**COUNTY OF SAN MATEO  
PLANNING AND BUILDING DEPARTMENT**

**SUBJECT:** EXECUTIVE SUMMARY: Consideration of a Bayside Design Review Permit and Non-Conforming Use Permit, to legalize 365 sq. ft. of existing construction and permit a 290 sq. ft. addition to an existing two-story residence to create an attached two car garage, on a 6,288 sq. ft. non-conforming parcel. Minimal grading is proposed, and no tree removal is required. The property is located at 747 Lakeview Way in the unincorporated Emerald Lake Hills area of San Mateo County.

County File Number: PLN 2020-00228 (Baker/Fong)

A07  
Exterior  
Elevations

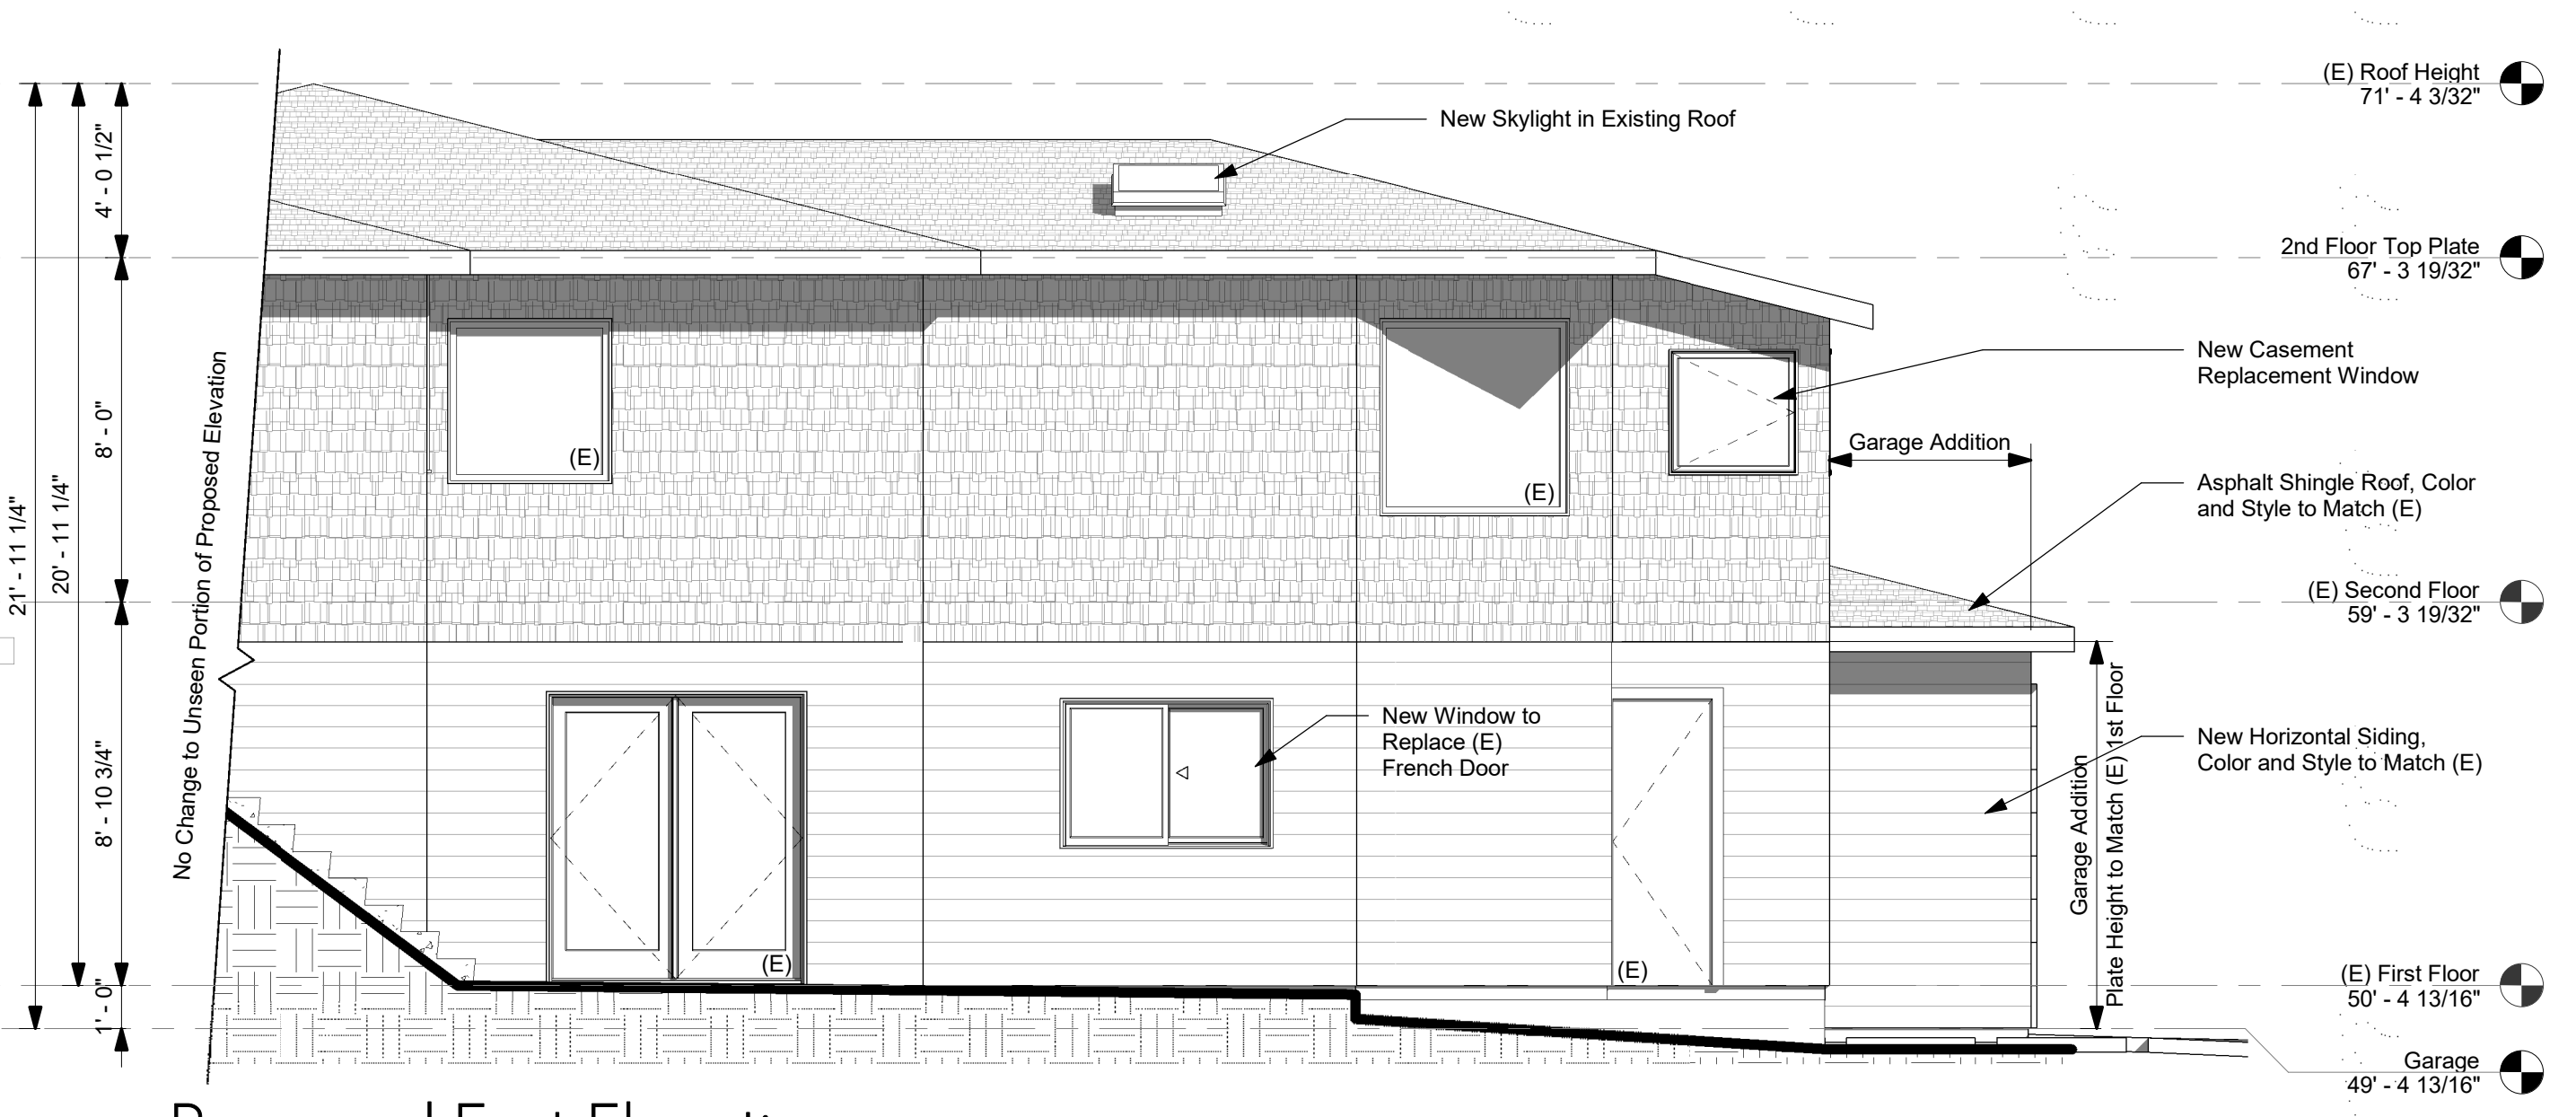
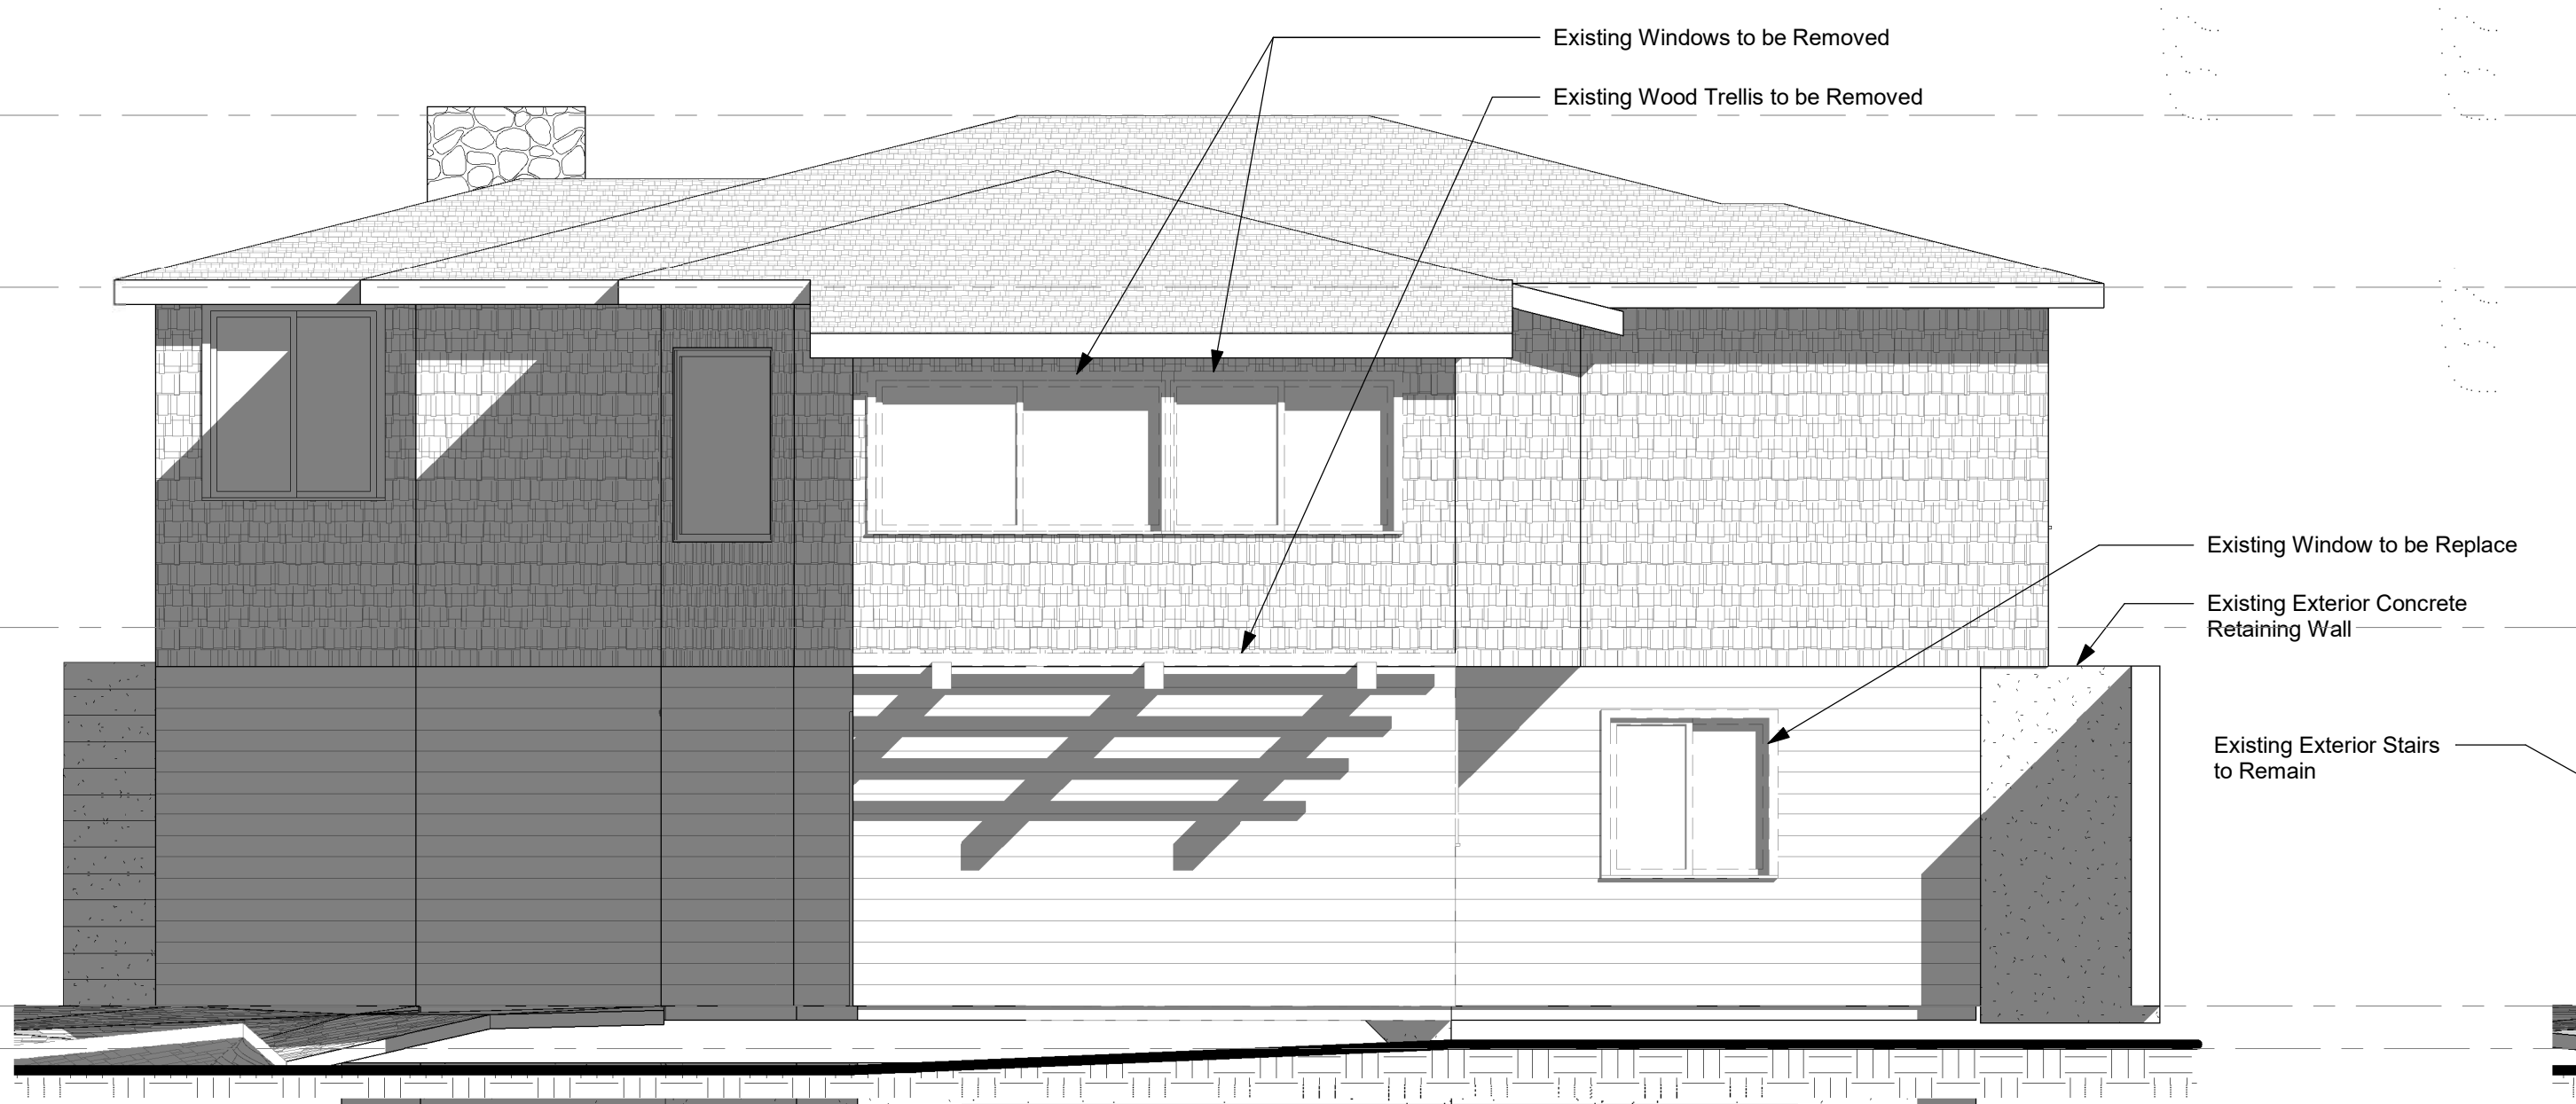
The project was heard on July 6, 2021, at the Emerald Lake Hills Design Review meeting. There was no public written correspondence received and no public member in attendance at the meeting. At the hearing, the Design Review Officer (DRO) recommended that the proposed garage door be modified to have windows, to prevent the appearance of blank walls, and the window patterns be aesthetically pleasing and proportioned. The DRO also stated that the proposed colors and materials are consistent with those recommended in the standards. With the recommended condition, the proposed addition is consistent with applicable Design Review Standards, Section 6515.15 of the Zoning Regulations.

The DRO indicated at the hearing that the proposed garage door be modified to have windows, to prevent the appearance of blank walls, and the window patterns are aesthetically pleasing and proportioned.

2. The garage door shall be modified to include windows to increase compliance with design standards on this elevation. Revised plans showing the proposed color and material application shall be submitted for review by the Design Review Officer prior to the Planning Commission hearing.
